**STAFF REPORT:** 08/13/2025

**APPLICATION NUMBER:** HDC2025-00113

**ADDRESS:** 8715 WOODWARD

**SCOPE:** REPLACE HISTORIC WOOD & STEEL WINDOWS

**PROPOSED** →

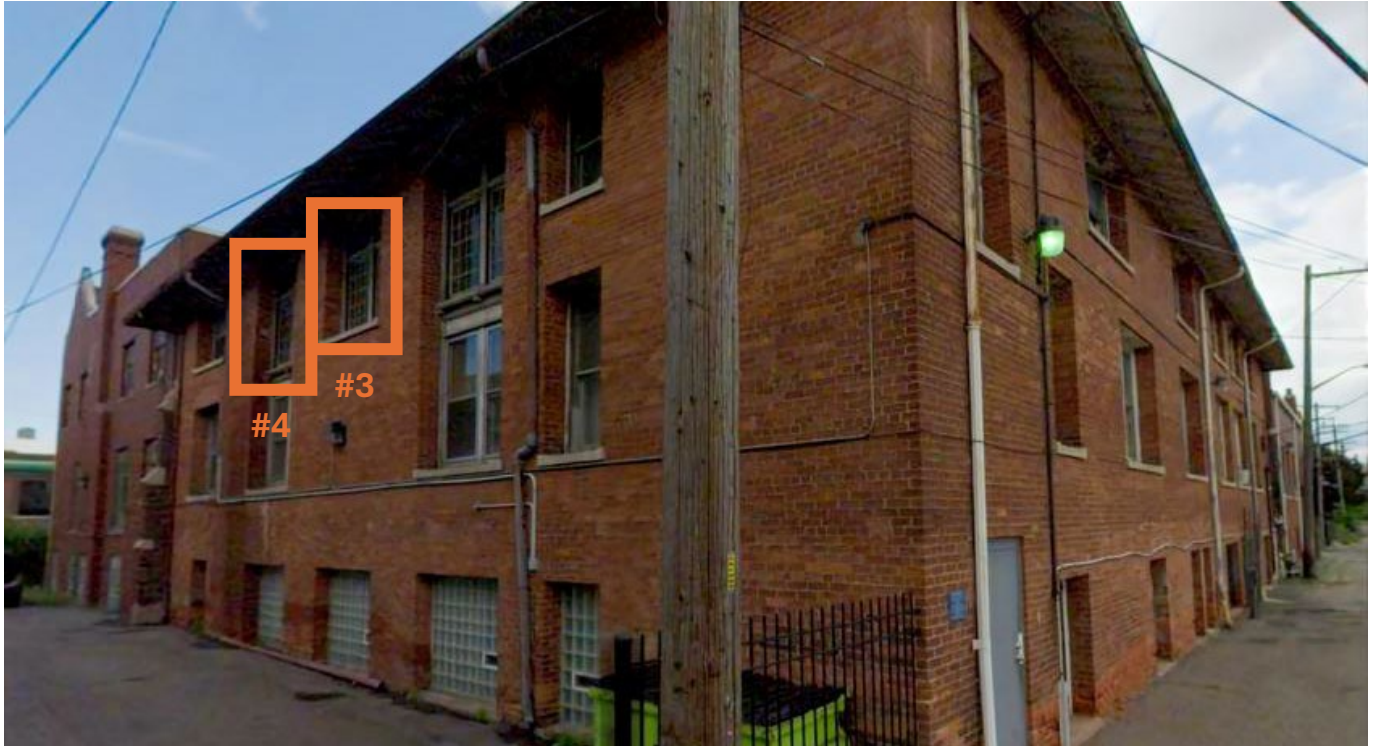
- Windows #1 and #2 face Woodward Ave and are visible from the sidewalk and the street.

- Although the existing steel casement windows are distinctive, character-defining features, considering the amount of bowing, deterioration from rust, and alteration to include the AC unit, it is staff's opinion that the existing historic steel casement window units are beyond repair.
- The Elements of Design (Sec. 21-2-150) mention that "metal occurs in doors and in window frames in some openings in the church complex."

*Vinyl "endvent" slider in white  
with white aluminum wrap*

**WINDOW #4**

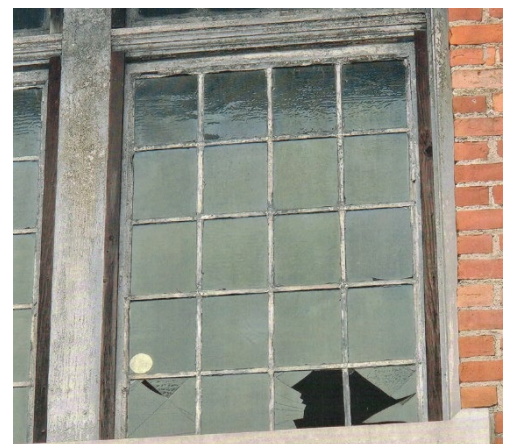
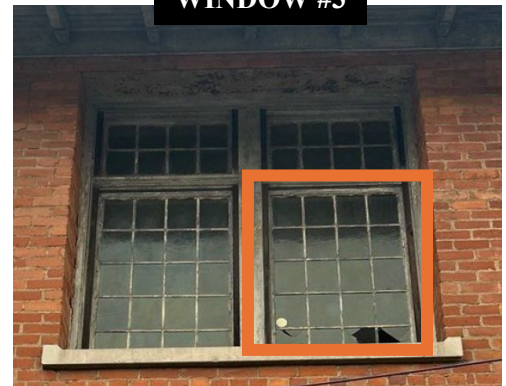
- Windows #3 and #4 face North toward the shared parking space between the church and the townhomes.

*Fixed vinyl window in white  
with white aluminum wrap*

- Photos provided with the application show relatively minor deterioration of the wood windows, such as peeling paint and broken panes of glass.
- The installation of the vinyl windows and aluminum wrap does not follow NPS guidelines for replacement windows. As stated on the [Replacement Windows that Meet the Standards](#), “When historic windows exist, they should be repaired when possible. When they are too deteriorated to repair, selection of the replacement windows must be guided by Standard 6. Design, visual qualities, and materials are specific criteria provided by the Standard that are pertinent to evaluating the match of a replacement window. Evaluating the adequacy of the match of the replacement window involves the consideration of multiple issues.” Specifically, referencing the factors to consider in evaluating the match of a window:
